Re: Response to ADEQ Correspondence Dated September 17, 2014
2nd Quarter 2014 Progress Report
Whirlpool Corporation
Fort Smith, Arkansas
EPA No. ARD042755389
AFIN No. 66-00048
CAO LIS 13-202

ENVIRON International Corporation (ENVIRON), on behalf of Whirlpool Corporation, is submitting this response to your September 17, 2014, letter (received on September 22) providing comments on the 2nd Quarter 2014 Progress Report submitted on August 15, 2014. Arkansas Department of Environmental Quality (ADEQ) comments are provided in the text below and the respective response follows.

**Figure
2**

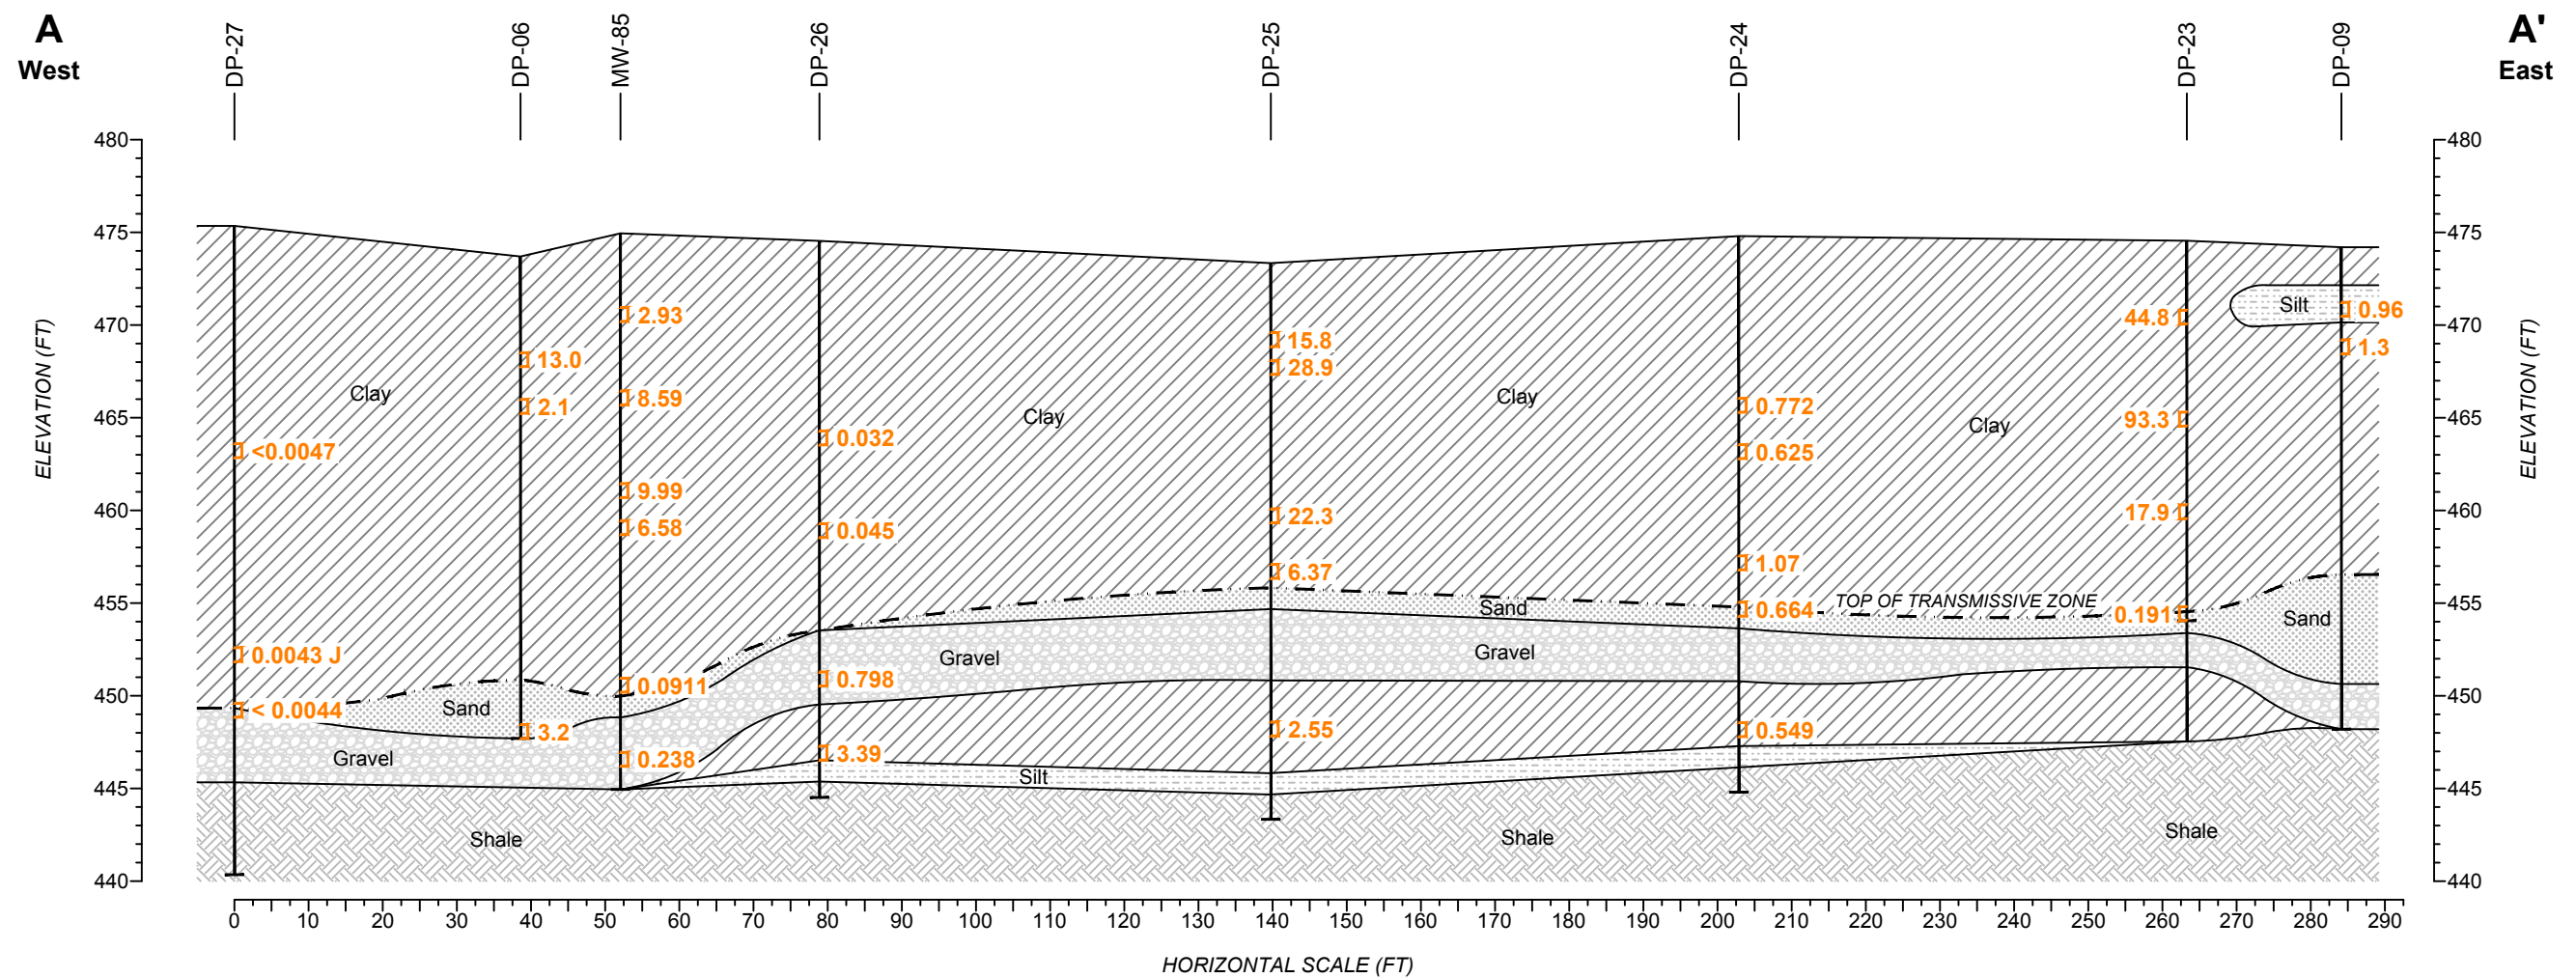
Please provide an explanation that the subsurface distribution of TCE would end abruptly at the western end of the drainage feature depicted in Figure 2. Examination of aerial photographs shows what appears to be a storm water drainage outlet located west of the drainage feature (latitude: 35.322649, longitude: 94.419852). This apparent drainage outlet is in the line with the western end of the drainage feature depicted in Figure 2. Given the abrupt absence of TCE in the subsurface west of the western end of the drainage feature, it is possible that a drain and subsurface conduit once fed storm water (and possibly TCE) to the drainage outlet. Please obtain MIP profiles and soil samples in the drainage channel immediately west of the storm water drainage outlet.

Figure 2 in Appendix E, *Area 1 Soil Investigation Summary Report* depicts the sample locations performed in accordance with the *Area 1 Soil Investigation Work Plan* dated May 27, 2014. No depictions of subsurface distribution of TCE are provided on the figure. An existing storm water catch basin is depicted on Figure 2 near the western end of former linear drainage feature.

During the September 2013 pre-design mobilization MIP borings M-73 and M-74 were completed adjacent to storm water inlets located on the north and south sides of the rail spur. The storm water inlets and M-73 and M-74 are located approximately 80 feet west along the storm water utility and the storm water catch basin referenced in ADEQ's comment. No electron capture device (ECD) responses were observed in M-73 and M-74 indicating that no further investigation to the west was necessary (M-73 maximum ECD

On August 5, 2014, M-307 was completed approximately 85 feet west of M-73 along the south side of the surface water drainage along the railroad tracks. No MIP response was observed warranting further delineation to the west (M-307 maximum ECD responses were 4×10^5). Locations and logs for the discussed borings are attached as Figure 2 and Appendix C.

Based upon the investigation efforts summarized above, the western extent of TCE impacts associated with the drainage feature identified in ADEQ's comment are considered fully delineated.

FIGURE
8

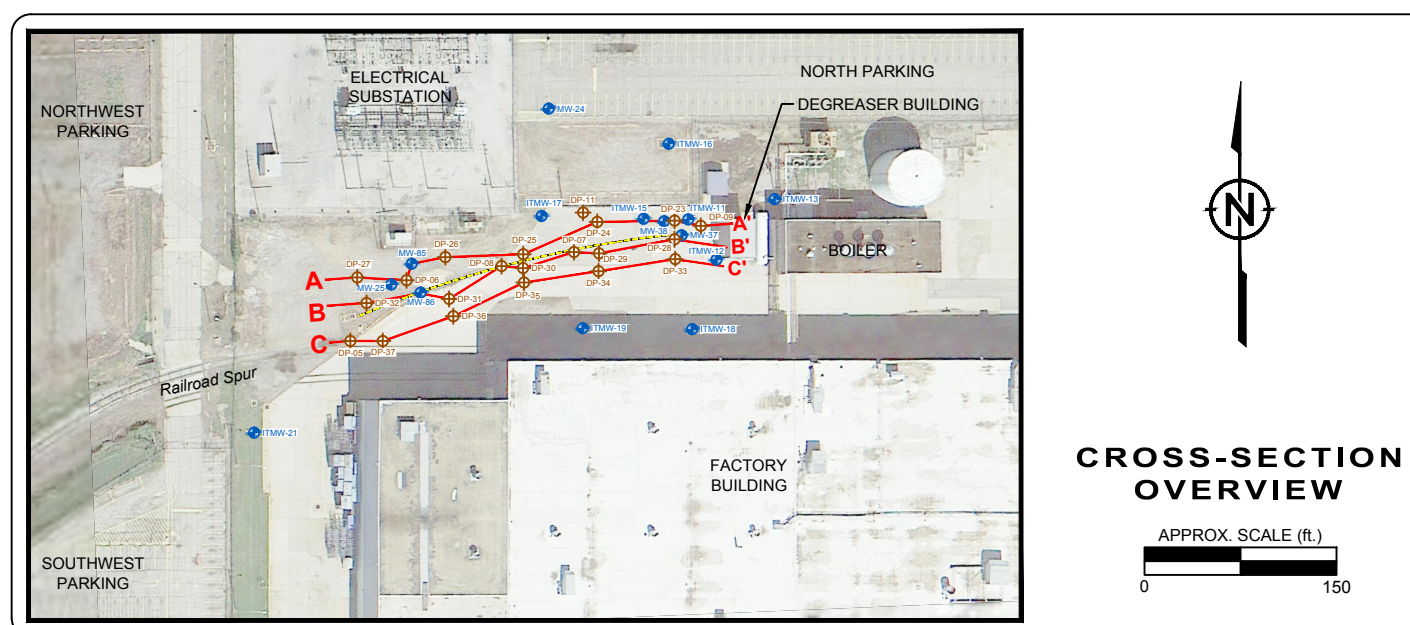
East-West labels on the cross sections are reversed. Please correct.

The East-West labels on Figures 8, 9 and 10 have been corrected and attached.

TABLE 1
SUMMARY OF STATISTICAL TEMPORAL TREND ANALYSIS OF MEAN CONCENTRATIONS
(2009 through 2nd Quarter 2014)
Whirlpool Facility
Fort Smith, Arkansas

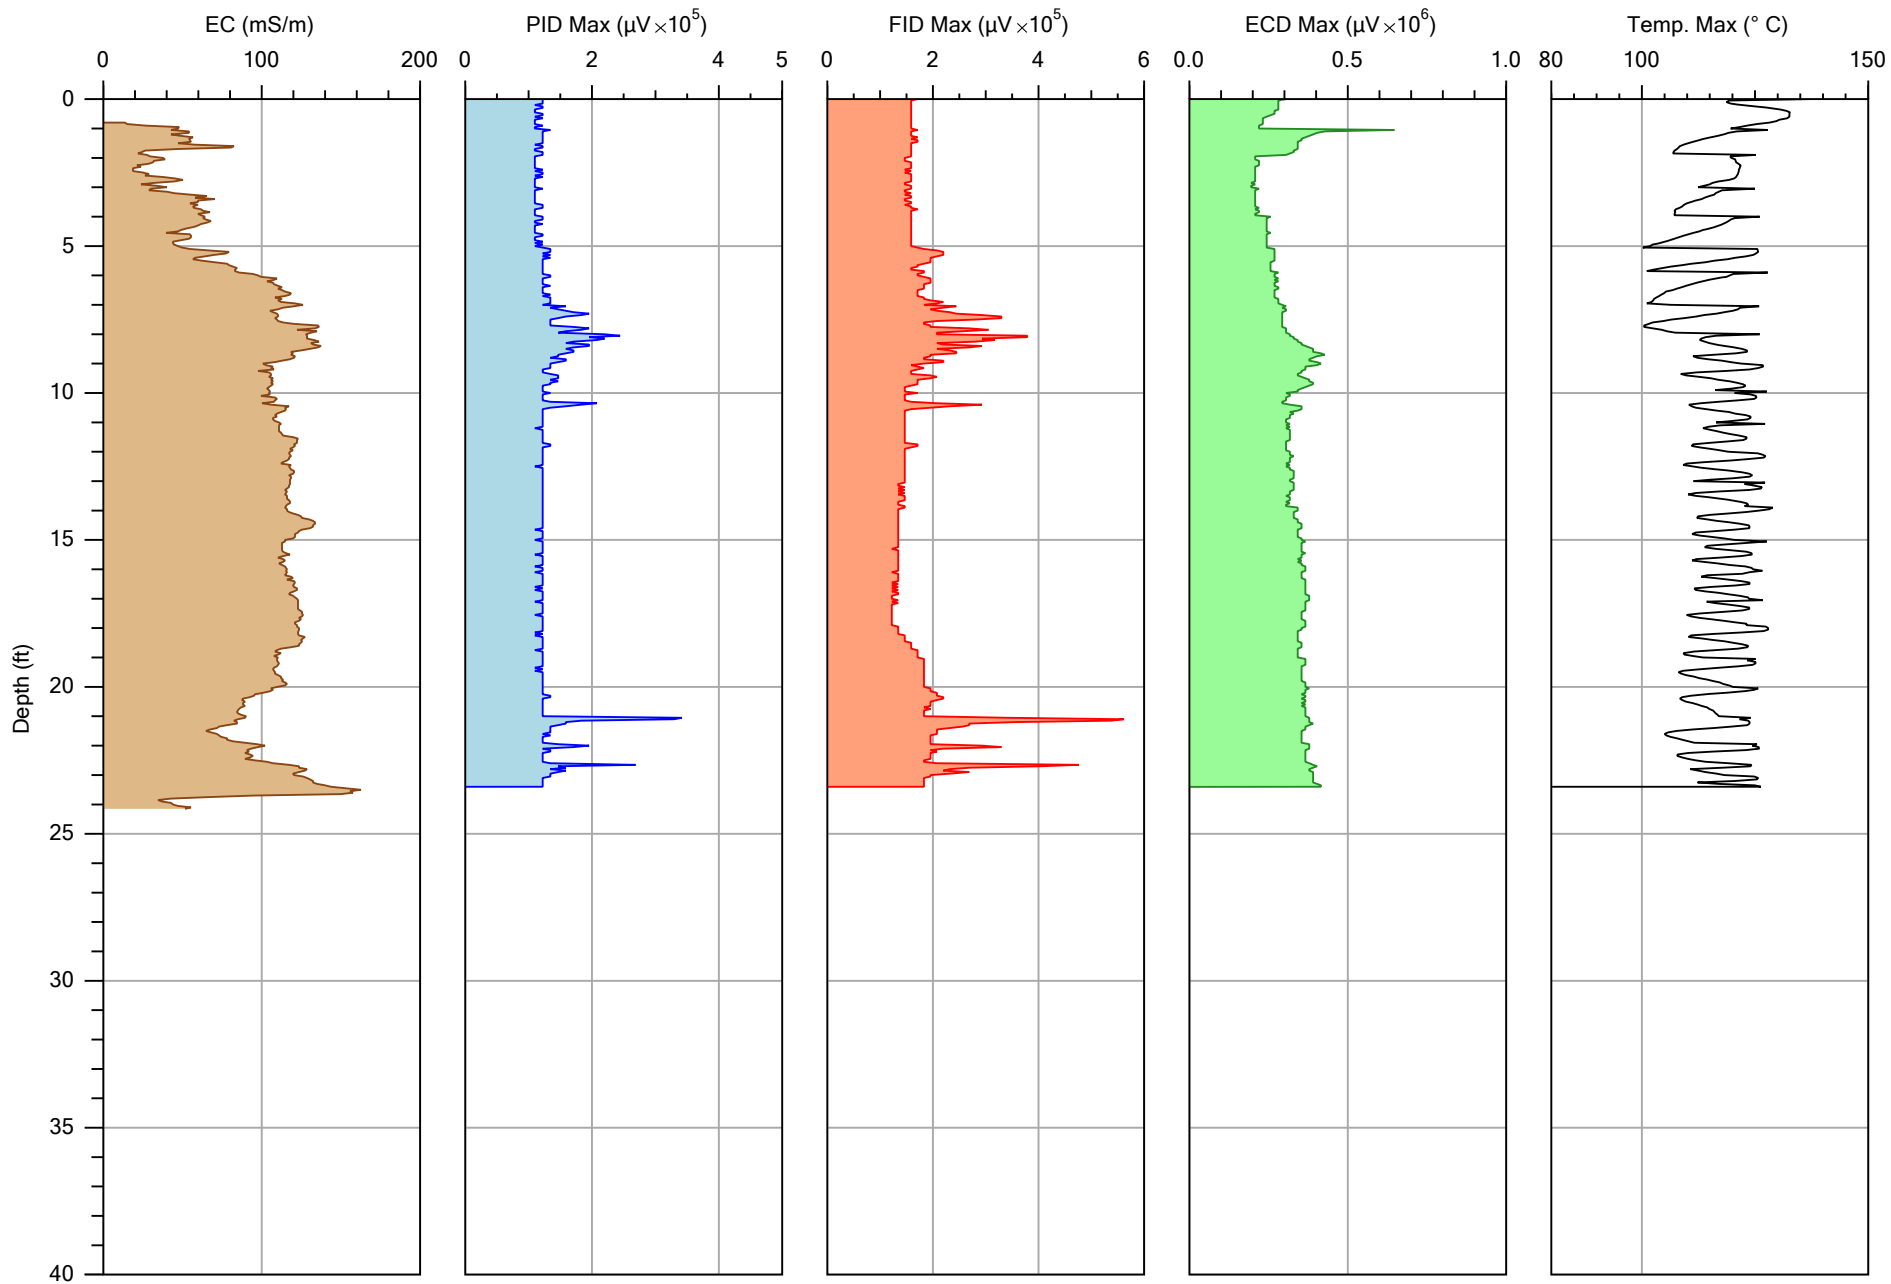
Based on the Mann-Kendall trend analysis of the northern plume shown in the Table 7, seven (7) wells display decreasing trends and five (5) wells were determined to have increasing trends. Please provide justification to support the conclusion made by the [sic] Whirlpool in determining that the plume is stable.

A trend analysis combining all of the wells within the north plume, south plume and entire groundwater plume based upon average TCE concentrations from 2009 through 2014 Second Quarter (see Table 7 in the *Second Quarter 2014 Groundwater Monitoring Report*) is presented as Table 1. The table shows that the average TCE concentrations for the:

- Northern plume exhibited a stable trend;
- Southern plume exhibited a decreasing trend; and
- Entire plume exhibited a decreasing trend.

The Mann-Kendall trend analysis for the grouping of all wells supports the plume stability conclusions.
